FIELD CHANGE ORDER

This FCO incorporates:
ECO RK05-00061, Air Handling
ECO RK05-00055, Capacitor Bracket

ECO G180-00008, Head Select
ECO G180-00009, Data Reliability

FCO RK05 S 0064 PAGE 1 of 81
Level of Urgency (LOU)

FIGURE NO. 8 NEW FILTER SYSTEM (TOP VIEW)

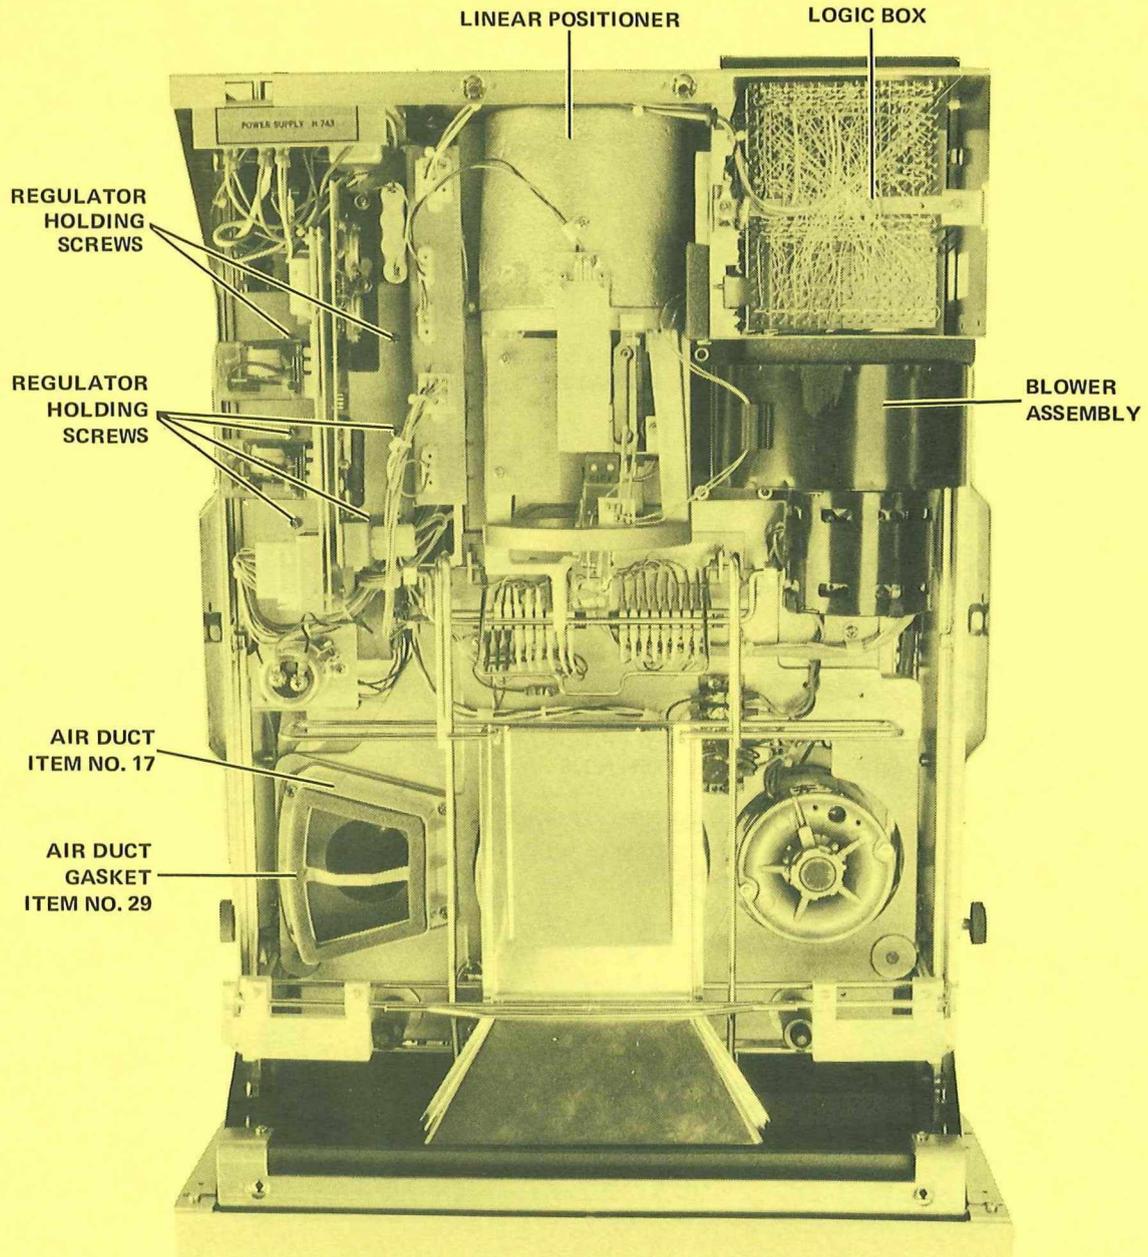
- () 1. (FIG #8) REMOVE BLOWER ASSEMBLY BY REMOVING FOUR ALLEN SCREWS IN BASE.

SKETCH OF BRACKET INSTALLATION
FIGURE #2

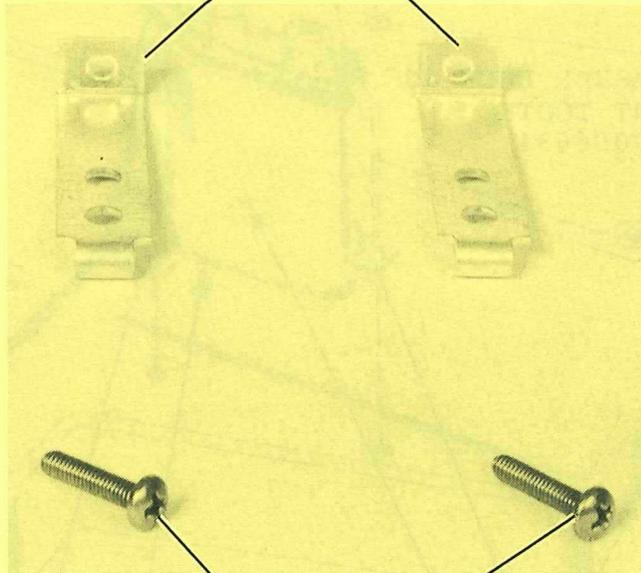
THE PURPOSE OF THIS ECO IS TO IMPROVE THE GROUNDING PATH FOR THE BLOWER RUN CAPACITOR. THE PRESENT BRACKET AND TAPE MOUNTING SCHEME MAY CAUSE RANDOM READ/WRITE ERRORS.

- () 1. REMOVE OLD BRACKET FROM CAPACITOR. BE CAREFUL NOT TO DAMAGE WIRES. SAVE WASHERS TO BE USED AGAIN.
- () 2. USING A PIECE OF SANDPAPER, CLEAN PAINT OFF BOTTOM OF CAPACITOR (OPPOSITE END FROM WIRES) AND AROUND EDGE WHERE NEW BRACKETS CONTACT. THIS WILL HELP GROUNDING OF CAPACITOR TO BASE CASTING.
- () 3. INSTALL NEW BRACKETS, FIG 1, USING OLD WASHERS PREVIOUSLY REMOVED; THE SCREWS SHOULD BE TIGHTENED TO 10 " LBS.

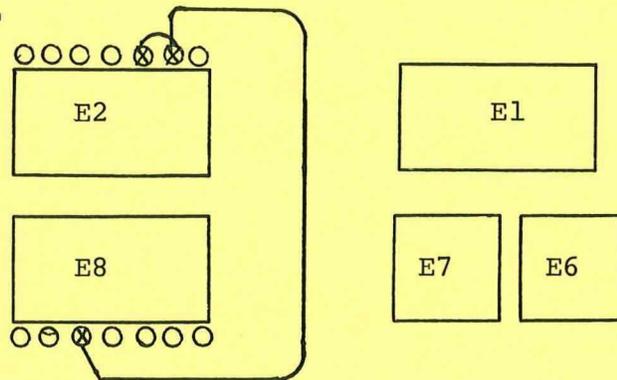
- () 1. (FIG #I) REMOVE THE SCREWS LOCATED IN EACH CORNER OF THE MODULE TO REMOVE THE SHIELD ATTACHED.
- () 2. PERFORM ALL SOLDERING ON THE NON-COMPONENT SIDE. THIS HELPS TO ELIMINATE ACCIDENTAL SPLASHING OF SOLDER ON OTHER PARTS.
- () 3. CUT ETCH THAT RUNS FROM E6 PIN 7 TO FEED THRU SIDE I (COMPONENT SIDE) AS SHOWN BELOW.

USE A SHARP KNIFE AND REMOVE APPROX 1/16" OF THE ETCH.

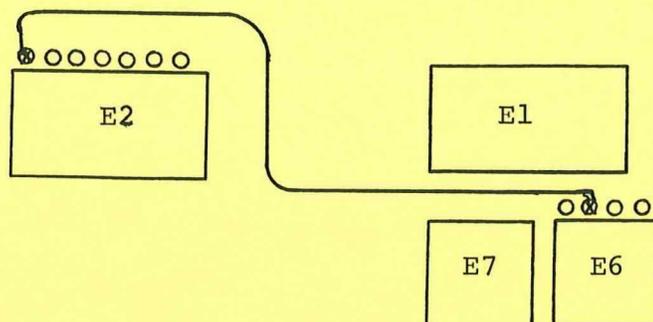
- () 4. ADD WIRE FROM E8 PIN 3 TO E2 PIN 9 AND PIN 10 AS SHOWN BELOW ON THE COMPONENT SIDE OF THE MODULE.

TRY TO PLACE WIRE AS SHOWN BUT DO NOT CEMENT UNTIL ALL WIRES ARE INSTALLED.

WHEN INSTALLING THE SHORT JUMPER FROM E2 PIN 9 TO E2 PIN 10 DO NOT LET ANY BARE WIRE PROTRUDE ENOUGH THAT IT MAY LATER SHORT OUT TO THE ETCH BELOW IT.

FIGURE NO. 1 ECO G180 00008

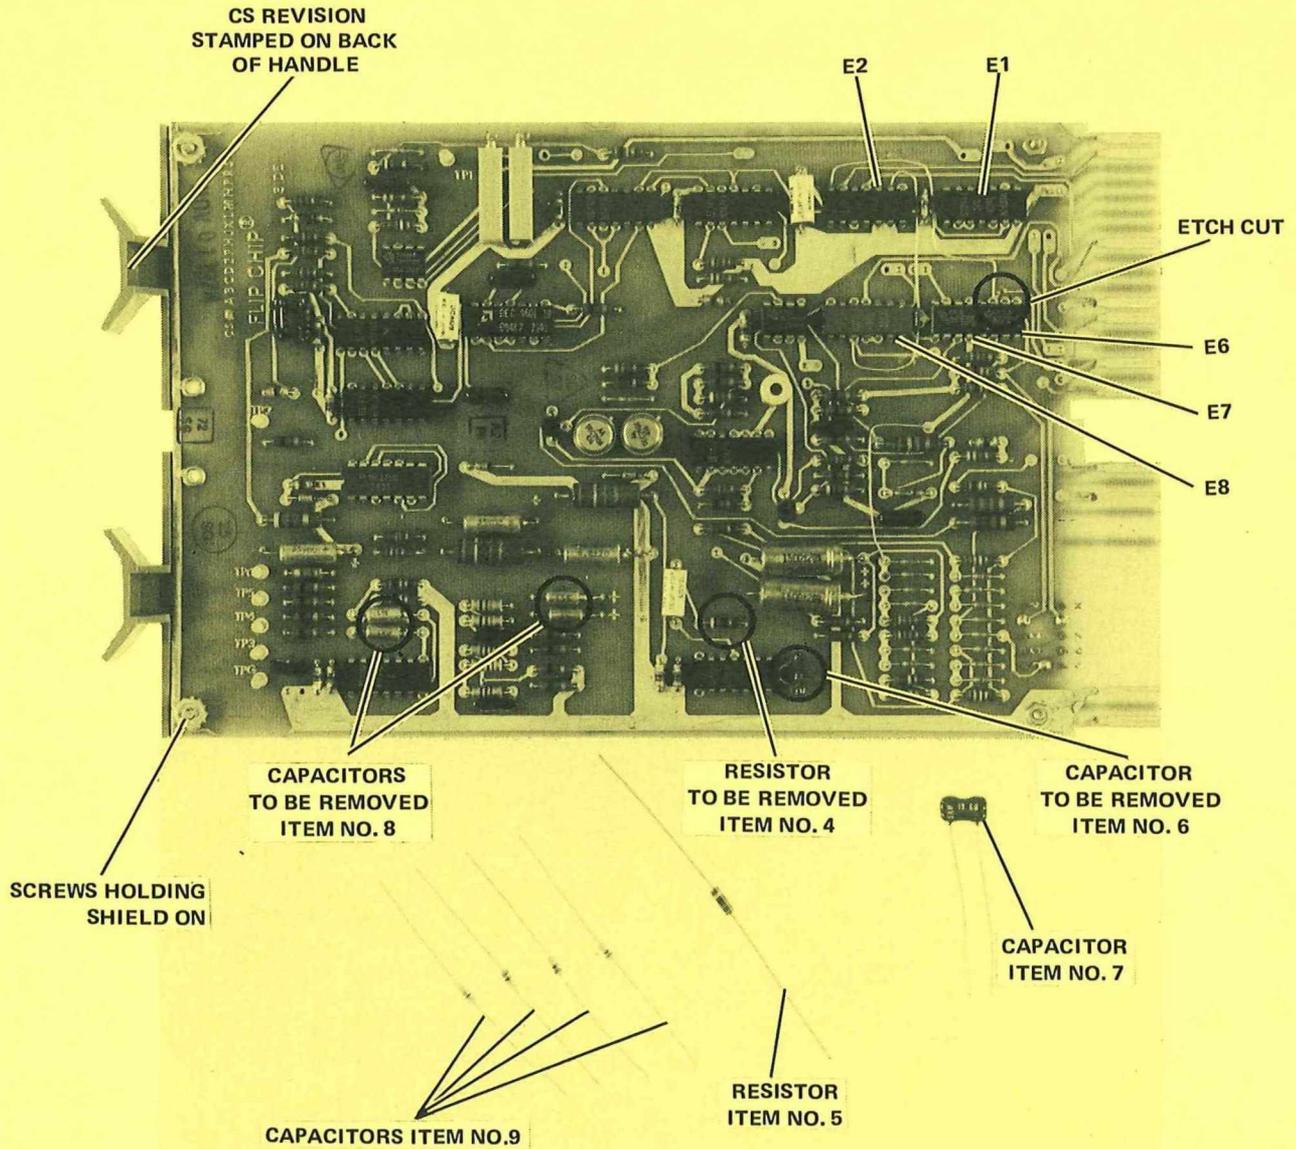
THE PURPOSE OF THIS ECO IS TO SOLVE OCCASIONAL HARD CHECK SUM ERRORS OR APPARENT WRITING OF DATA IN THE WRONG SECTORS. HEAD SELECT LINE IS RECEIVED BY A 75452 AND HAS POTENTIALLY ZERO NOISE MARGIN, ALLOWING SIMULTANEOUS SELECTION OF BOTH HEADS, RESULTING IN DATA ERRORS IN THE READ OR WRITE MODE.

- () 4. (FIG. 1) REMOVE 4 CAPACITORS AS SHOWN (ITEM#8) AND REPLACE WITH 4 CAPACITORS PROVIDED.
- () 5. (FIG 1) REMOVE 1 RESISTOR (ITEM#4) AND INSTALL THE NEW RESISTOR PROVIDED (ITEM#5).
- () 6. (FIG 1) REMOVE 1 CAPACITOR (ITEM#6) AND REPLACE WITH 18 PF CAPACITOR (ITEM#7).
- () 7. USING THE SOLVENT, CLEAN ALL SOLDER JOINTS.
- () 8. CHECK FOR ANY SOLDER SPLASHES OR EXCESS SOLDER.
- () 9. WITH A SHARP OBJECT, ETCH THE NEW CS REVISION INTO THE PLASTIC HANDLE (FIG 1)

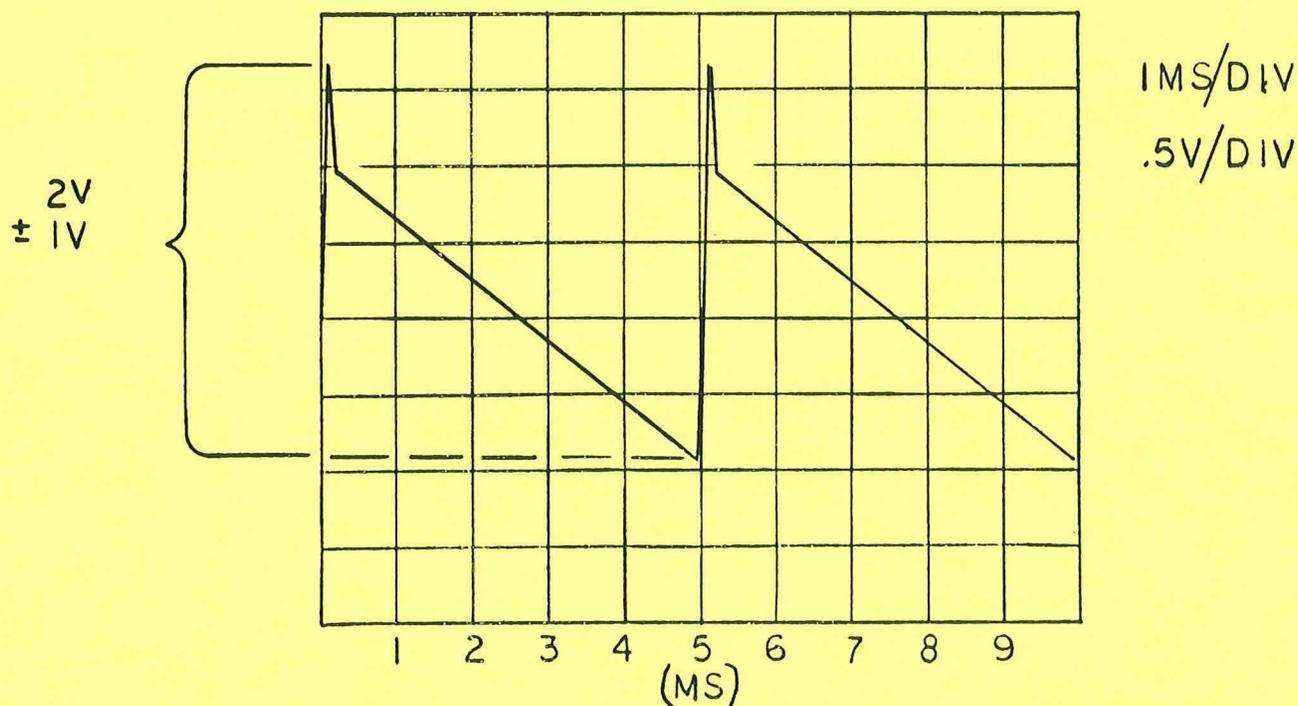
- () 6. ADJUST R2 SLOWLY CW UNTIL THE SIGNAL JUMPS OFF THE SCREEN, AT THIS TIME E1, THE SECOND OVER-VOLTAGE REGULATOR, HAS BEGUN TO OPERATE.

WARNING: THIS IS A CRITICAL ADJUSTMENT. DO NOT TURN THE POT ANY FURTHER THAN IT IS NECESSARY TO CAUSE THE P-P RIPPLE TO INCREASE FROM THE 200-500 MV TO BETWEEN 1 AND 2V. AT THIS TIME REDUCE THE GAIN ON THE SCOPE SO THE SIGNAL CAN BE OBSERVED. THE SIGNAL SHOULD RESEMBLE THE DRAWING BELOW.

TYPOGRAPHICAL ERROR IN FCO
RELEASE OF JUNE 14, 1976.
CORRECT VOLTAGE ADJUSTMENT
IS 15 V.D.C.

FIGURE NO. 2 8 TO 20V REGULATOR

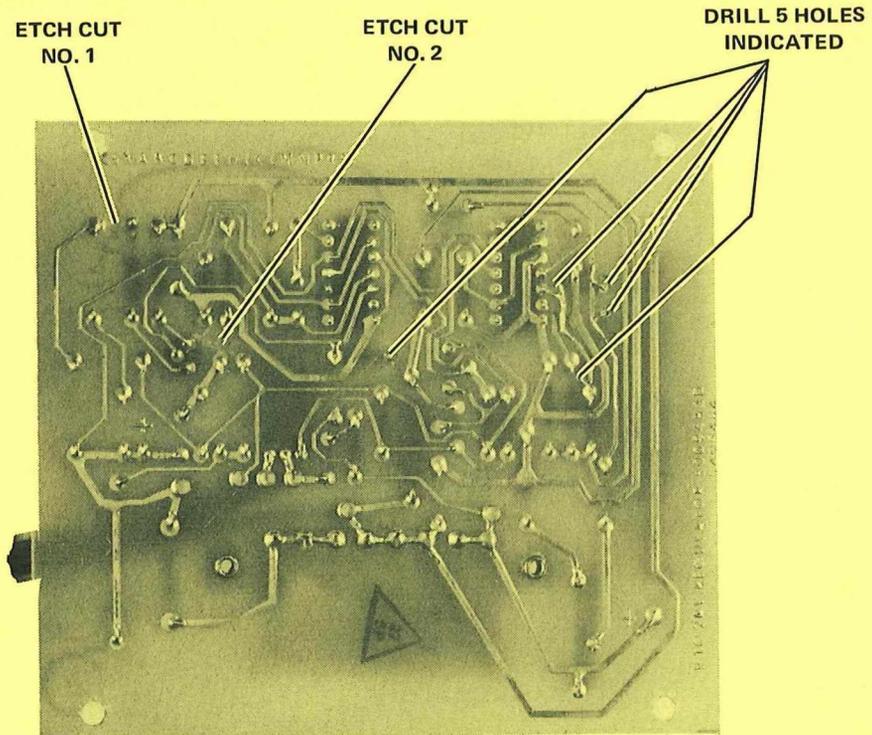
- () 1. (FIG #3) REMOVE R4 - CUT WITH SIDE CUTTERS CLOSE TO P.C. BOARD.
- () 2. (FIG #2) CUT ETCH #1 ON SIDE 2 OF PRINTED CIRCUIT BOARD BETWEEN R3 AND R4.
- () 3. (FIG #2) CUT ETCH #2 ON SIDE 2 OF PRINTED CIRCUIT BOARD BETWEEN R9 AND R22.
- () 4. DRILL FIVE (5) HOLES AS SHOWN IN FIG #2 WITH A #56 DRILL OR EQUIVALENT. WHEN DRILLING THE HOLES BE CAREFUL THE SPACING BETWEEN HOLES IS PROPERLY

AFTER THE DIODES ARE INSTALLED LOOK AT FIGURE #2, NOW SOLDER THE TWO LEADS ON THE FAR RIGHT TO THE PRINTED CIRCUIT RUN ON ITS LEFT. CHECK THAT IT IS THE SAME AS IN FIG #1.
